Access Compliance Report Public Rights-of-Way (Curb Ramps)

Main Street: E_LARKSTONE_DR Cross Street: WHEELER_PL Location: SE

ADA ID: RPAT211022132121 Ramp Type: Type 1 - Perpendicular Diagonal Initial Pass/Fail: Fail Overall Compliance: No Severity Score: 19

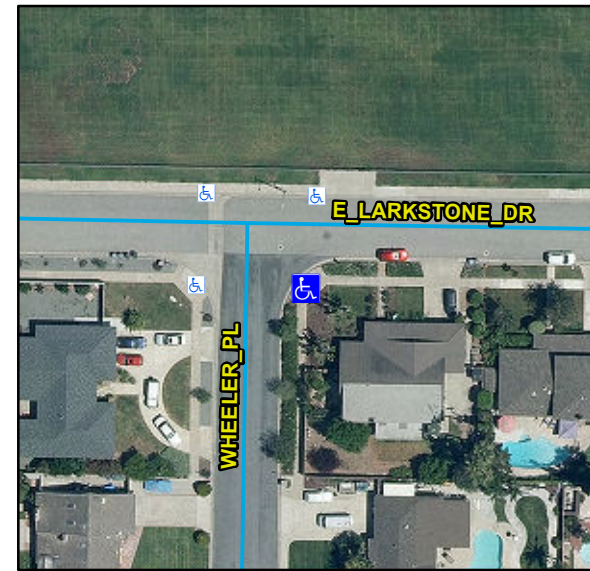
Compliance	Description	Data	Compliance	Description	Data
N/A	Ramp Length (in)	87	N/A	Flare Type LT	
No	Ramp Width (in)	44			N/A
No	Ramp Run Slope (%)	11.6	N/A	Flare Slope LT (%)	N/A
Yes	Ramp Cross Slope (%)	1.4	N/A	Flare Traversable LT	N/A
N/A	Landing Present	N/A	N/A	Flare Type RT	
N/A	Landing Length (in)	N/A			N/A
N/A	Landing Width (in)	N/A	N/A	Flare Slope RT (%)	N/A
N/A	Landing Run Slope (%)	N/A	N/A	Flare Traversable RT	N/A
N/A	Landing Cross Slope (%)	N/A	N/A	DWS Provided	N/A
N/A	Landing Movement Obstructed?	N/A	N/A	DWS Contrast	N/A
	Landing Movement Type	N/A	N/A	DWS Length (in)	N/A
N/A	Landing Shared	N/A	N/A	DWS Full Width	N/A
N/A	Clear Space	Yes	N/A	DWS Offset Left (in)	N/A
N/A	Clear Space To Crosswalk (in)	N/A	N/A	DWS Offset Right (in)	N/A
N/A	Marked Crosswalk 1	No	N/A	Marked Crosswalk 2	No
	Crossing 1 Direction	N		Crossing 2 Direction	W
	Marked Crosswalk 1 Width (in)	N/A		Marked Crosswalk 2 Width (in)	N/A

N/A	Ramp Inside Crosswalk 1	N/A	Yes	Ramp Inside Crosswalk 2	N/A
	Crossing 1 Slope (%)	1.5		Crossing 2 Slope (%)	1.9
	Crossing 1 Cross Slope (%)	0.1		Crossing 2 Cross Slope (%)	1.8
N/A	Gutter Ponding	N/A	No	Curb Slope	6.8
Yes	Gutter Lip Height (in)	0		Road Run Slope (%)	2.5
N/A	Gutter Run Slope (%)	N/A		Road Cross Slope (%)	0.3
N/A	Gutter Cross Slope (%)	N/A			
Yes	Overall Surface Condition: Acceptable		Yes	Perp Joint Present	Yes
	Cross Gutter Present?	No		Spandrel Present?	No
	Replace Cross Gutter?	N/A		Replace Spandrel?	N/A

Remove & Replace Curb Ramp With Two New Directional Ramps or Equivalent.

R304.2.2, R304.5.1, STD 1115
